# RotorSport UK Ltd Service Bulletin

<b>Title: PTFE oil hose construction and new thermostat</b>		
<b>SB No.: 062 Iss1</b>	<b>Related documents</b> MC No: MC-222 CCAR No.: None	<b>Compliance Category:</b>  <b>OPTIONAL</b> <del>or</del> <b>RECOMMENDED</b> or <b>MANDATORY</b>
<b>Applicability</b>		
<b>Aircraft type &amp; model:</b>  MT-03, MTOsport, Calidus	<b>Aircraft serial Nos. affected:</b>  Any a/c presently fitted with rubber hoses between thermostat and oil cooler and/or the oil return line(s)	
This form is the response from RotorSport UK Ltd either against a problem found in the product in service requiring a containment or rectification action, or as service information for aircraft modification incorporation. For help, contact RotorSport on 44(0)1588 650769, or email info@rotorsport.org.		
<b><u>Reason and overview of the Service Bulletin (cause of problem if known)</u></b> Under MC-222 stainless-steel braided/PTFE-lined hoses may be fitted to MT-series and Calidus aircraft in place of the original rubber hoses. This hose construction offers an improved service life and removes the Rotax requirement for replacement (of rubber hoses) every five years. As the hose end fittin

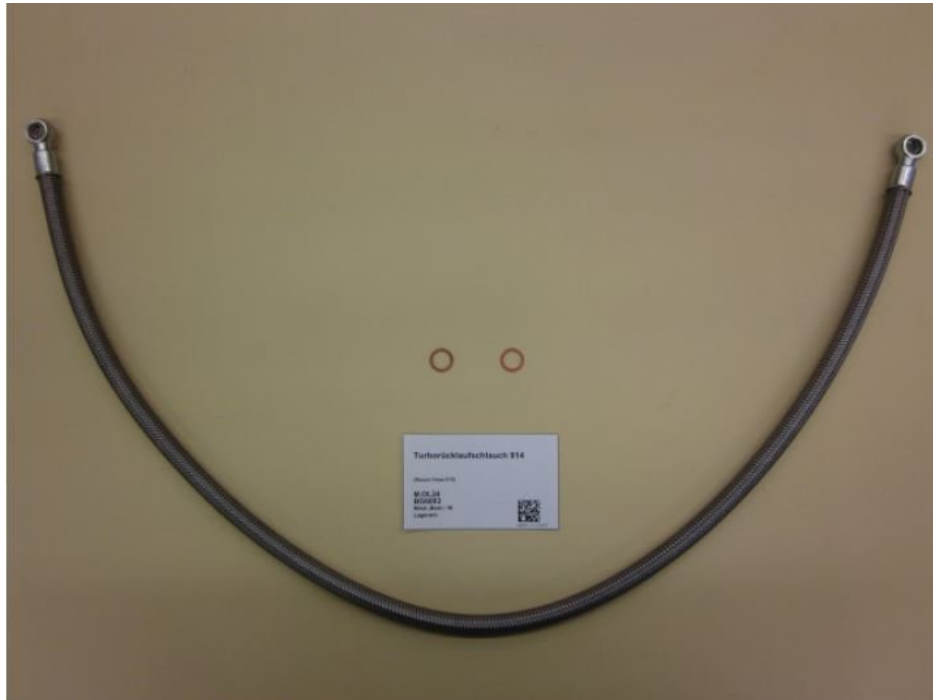
Thermostat set

Sump return

Turbo return

- M.OL17 (BG4077) Oil thermostat set (including pump adaptor and seal)
- M.OL18 (BG4084) Sump return hose 912ULS
- RSD6355 Copper washer sump hose – 2-off

- M.OL17 (BG4077) Oil thermostat set (including pump adaptor and seal)
- M.OL19 (BG4085) Sump return hose 914UL
- M.OL24 (BG6003) Turbo return hose
- RSD6355 Copper washer sump hose – 2-off
- Rotax 230150 Copper washer turbo return banjo – 4-off

- C.OL14 (BG4464) Oil thermostat set (including pump adaptor and seal)
- C.OL201 (BG5128) Sump return hose 912ULS
- RSD6355 Copper washer sump hose – 2-off

- C.OL14 (BG4464) Oil thermostat set (including pump adaptor and seal)
- C.OL301 (BG5129) Sump return hose 914UL
